FOI Reference: CMTEDDFOI 2020-221

15	71	Email – CAT to Ministry Design – Blocks 13 & 16 Section 128 Holt	21 Apr 2020	Partial release	Sch 2 s2.2 (a)(ii)	Yes
16	72	Email – Show Cause Notices	3 Jun 2020	Partial release	Sch 2 s2.2 (a)(ii)	Yes
17	73-75	Show cause demerit points notice – Kenyon Hopkins – block 13 section 128	3 Jun 2020	Partial release	Sch 2 s2.2 (a)(ii)	Yes
18	76-78	Show cause demerit points notice – Kenyon Hopkins – block 16 section 128	3 Jun 2020	Partial release	Sch 2 s2.2 (a)(ii)	Yes
19	79-81	Show cause demerit points notice –CTECK HOP PTY LTD – block 13 section 128	3 Jun 2020	Partial release	Sch 2 s2.2 (a)(ii)	Yes
20	82-84	Show cause demerit points notice –CTECK HOP PTY LTD – block 16 section 128	3 Jun 2020	Partial release	Sch 2 s2.2 (a)(ii)	Yes
21	85-93	SDHDC checklist – Block 11 Section 128	12 Jun 2020	Partial release	Sch 2 s2.2 (a)(ii)	Yes
22	94-95	Letter to Rapid Regulatory Response Team from CTECKHOP Pty Ltd	17 Jun 2020	Partial release	Sch 2 s2.2 (a)(ii)	Yes

Notice to Show Cause – Demerit Points - Sch 2.2(a)(ii) Holt

Amendment	MINISTRY DESIGN	Site Plan	Drawing Title: Sch 2.2(a)(ii)	Suburb: Holt	Scale: 1:200	Job no.: 1412	Drawing Number: A101	Revision: J	
			Client: Delta Constructions	Date: 18.3.19	Drawn: PI

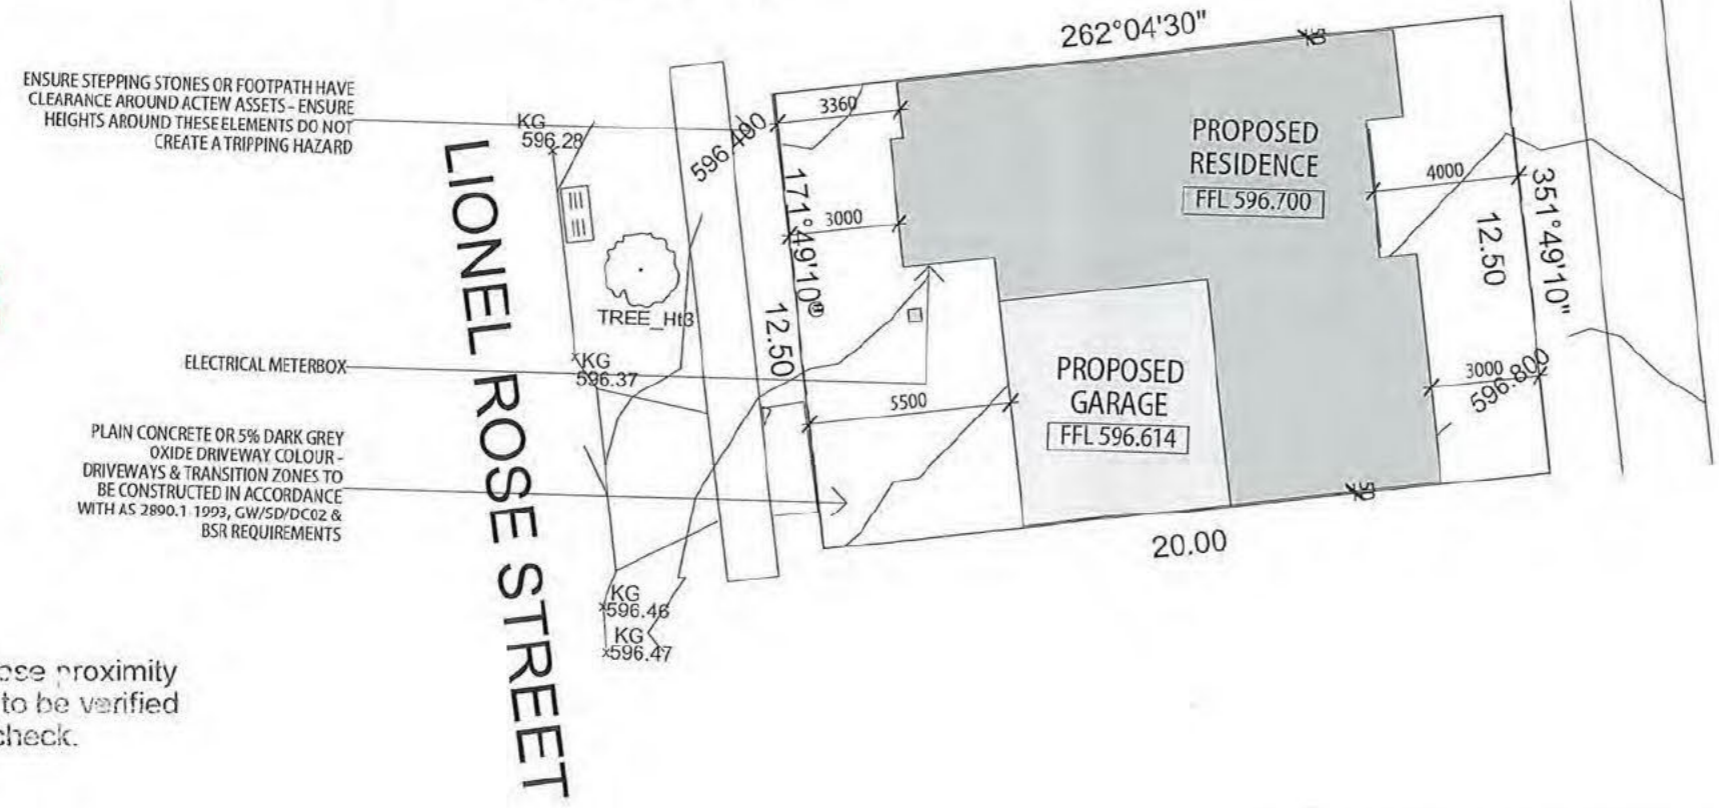
Rule 41 Principal private open space (PPOS) – The minimum dimensions required for the PPOS on a compact block are 4 metres by 4 metres. The plans show that the PPOS is only 4m by 3.74m for both blocks.

Appendix A

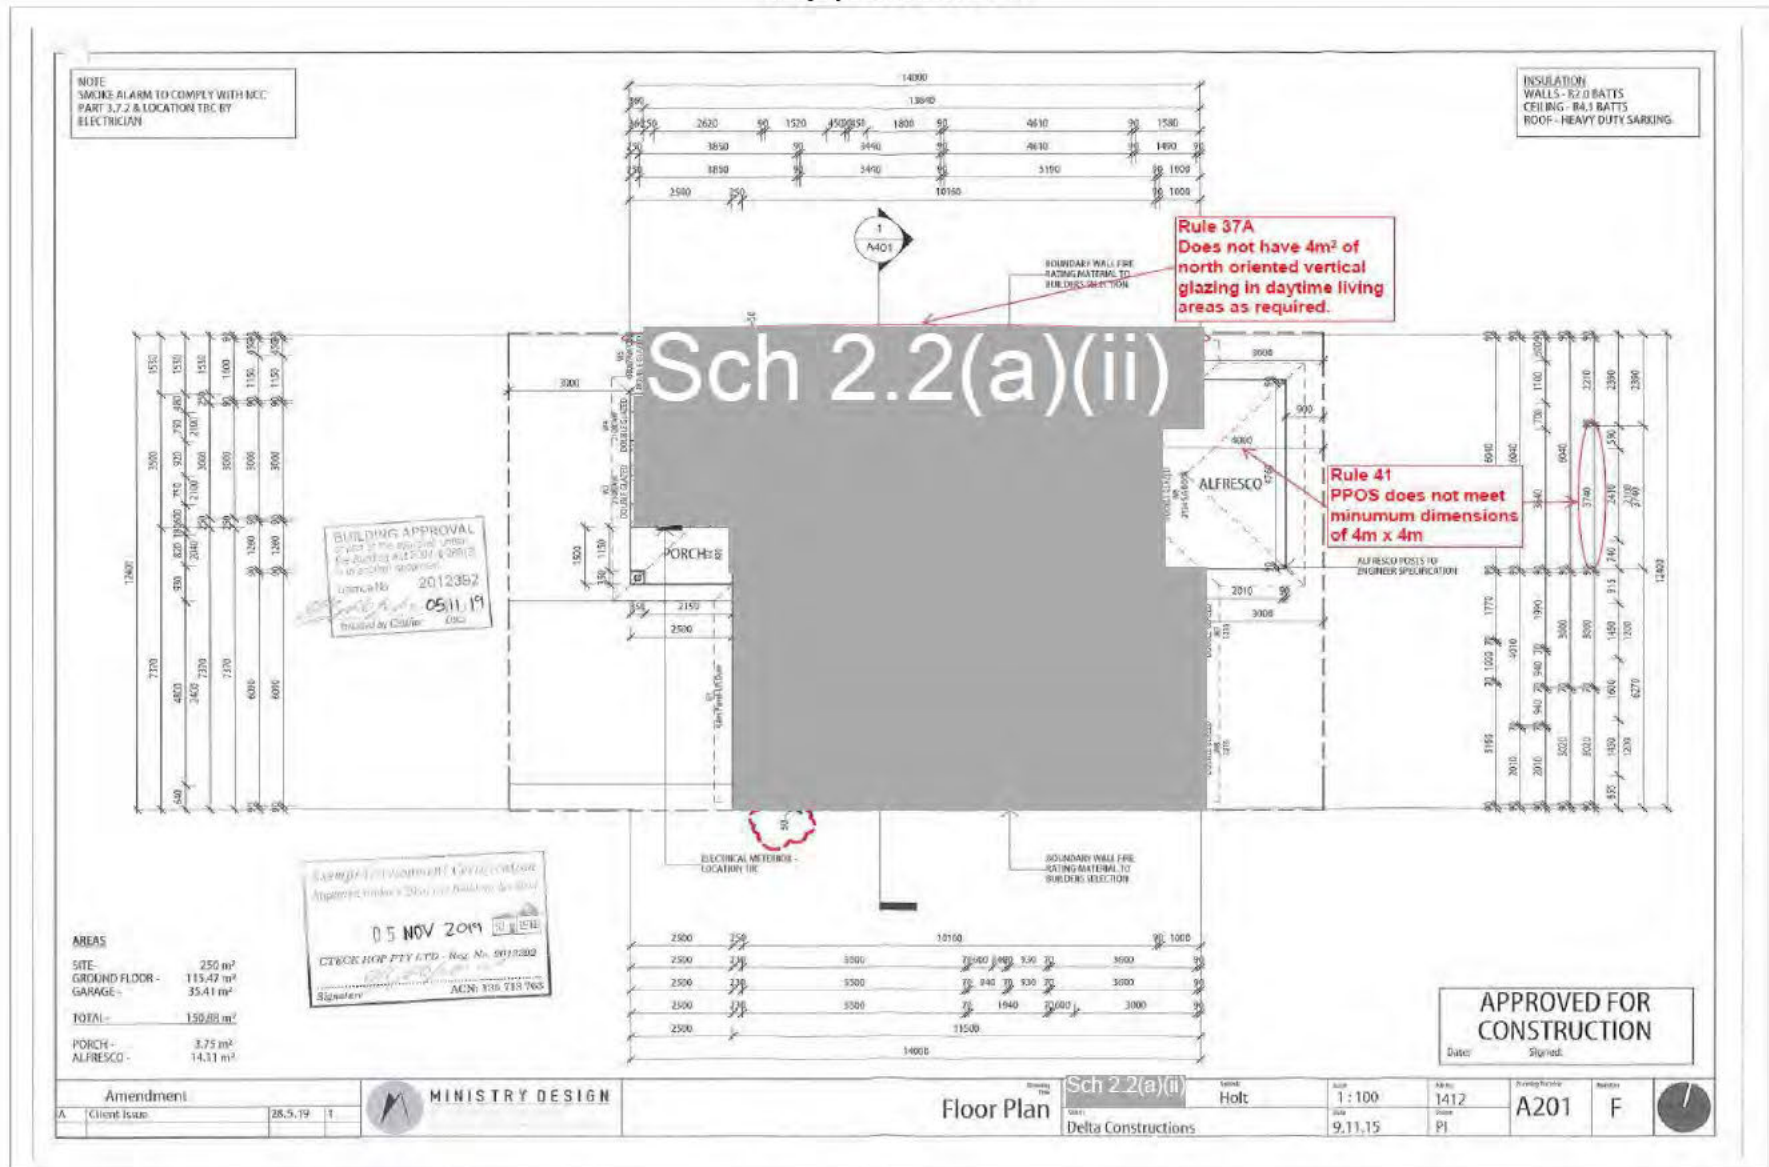
- i. The development does not have any vertical glazing that is oriented between 45 degrees east and 45 degrees west of north. The rule requires that 4 square metres of vertical glazing that is oriented between 45 degrees east and 45 degrees west of north must allow sunlight into a daytime living area.
- ii. The minimum dimensions required for the PPOS on a compact block are 4 metres by 4 metres. The plans show that the PPOS is only 4m by 3.74m.

Please see in red where the contraventions are circled.
